## STAFF REPORT

### PLANNING BOARD MEETING

**Case #32-17: SITE PLAN APPROVAL**

100 Duchaine Blvd  
(Map 134, Lot 5)

## SCHEME 1.1

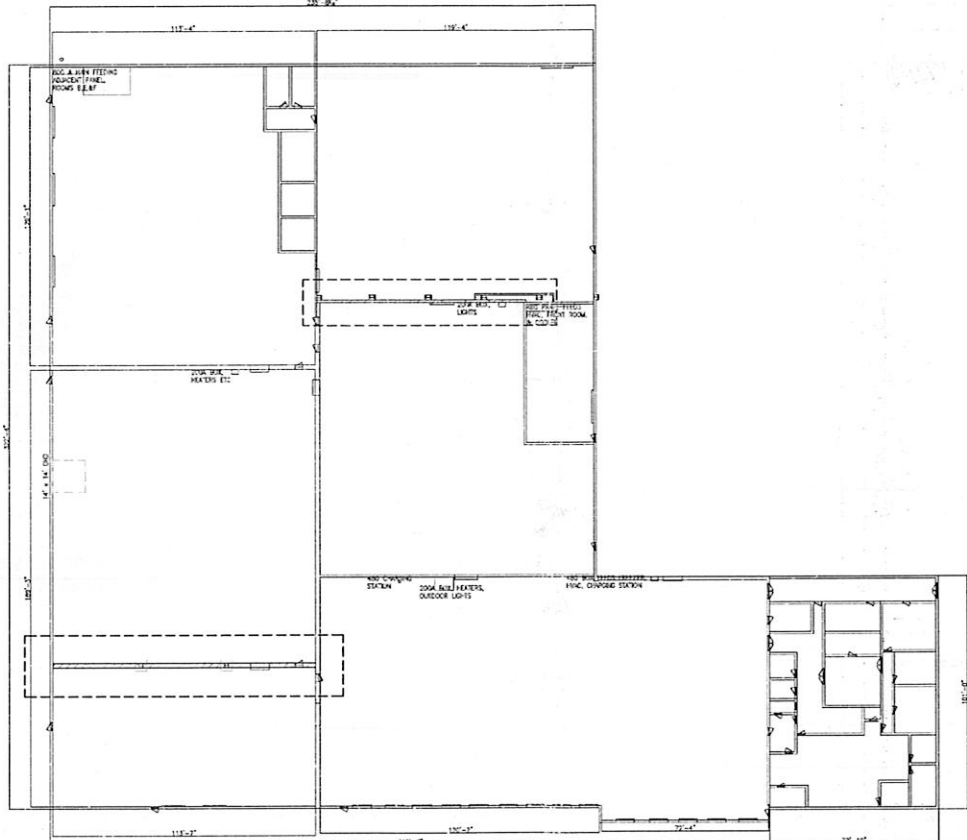
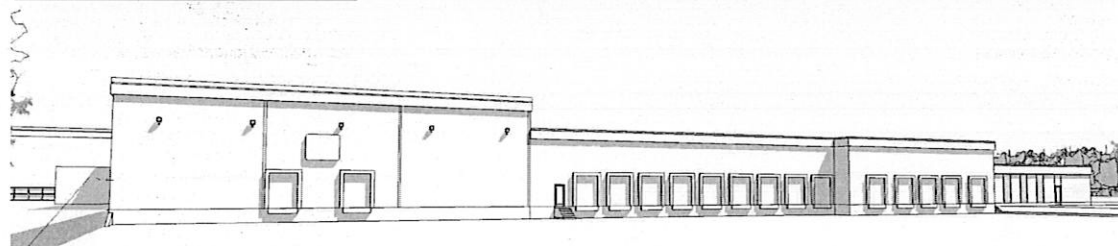
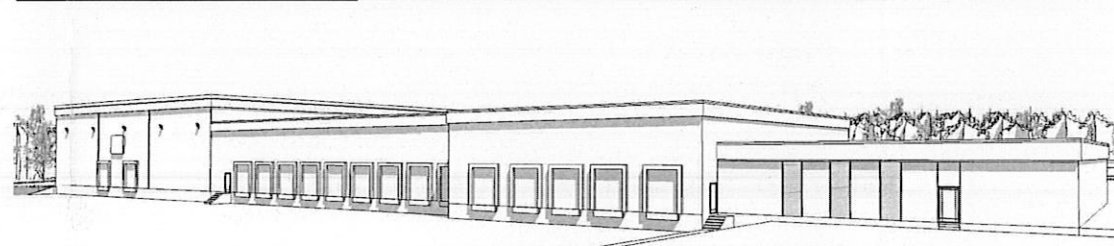
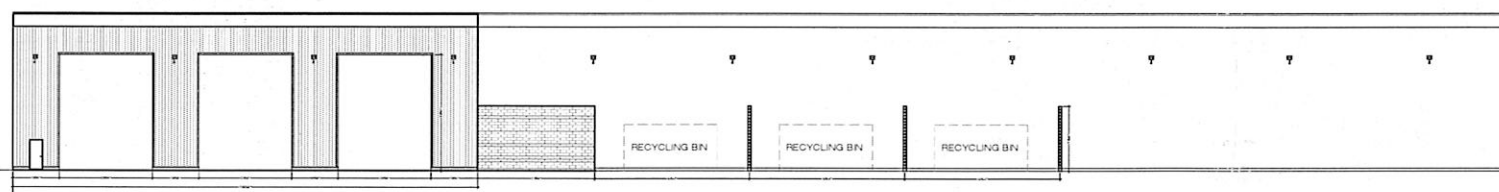
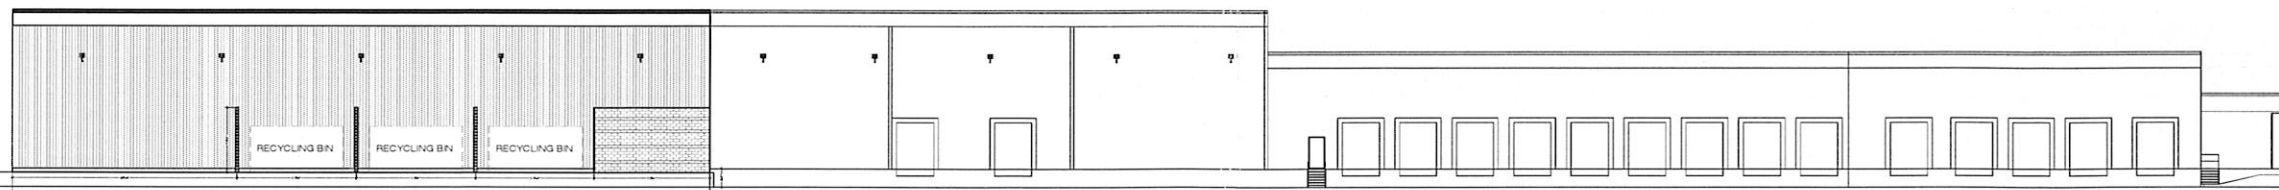
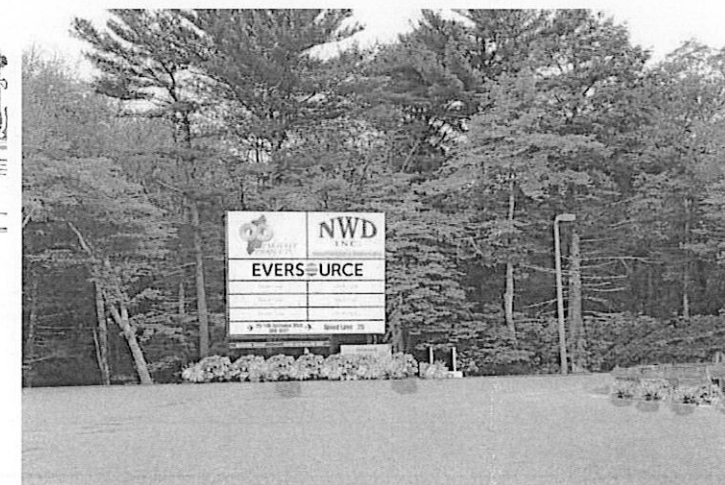
- ☐ Provide drawings and specifications for the solar canopy that have been omitted. [Staff has not been able to review the architectural features to determine the proposal affect on the visual environment.]
- ☐ Show all structural building elevations (front, sides and rear façades) that will be affected by the proposed project.

- ☐ For additions/alterations: label existing and new construction, as well as items to be removed.
- ☐ Identify all existing and proposed exterior materials, treatments and colors - including roofing, roof eaves, eave brackets, siding, doors, trim, sills, windows, fences, and railings.
- ☐ Show details of proposed new exterior elements.
- ☐ Show any exterior mechanical, duct work, and/or utility boxes.
- ☐ Include dimensions for building height, wall length and identify existing and proposed floor elevations.
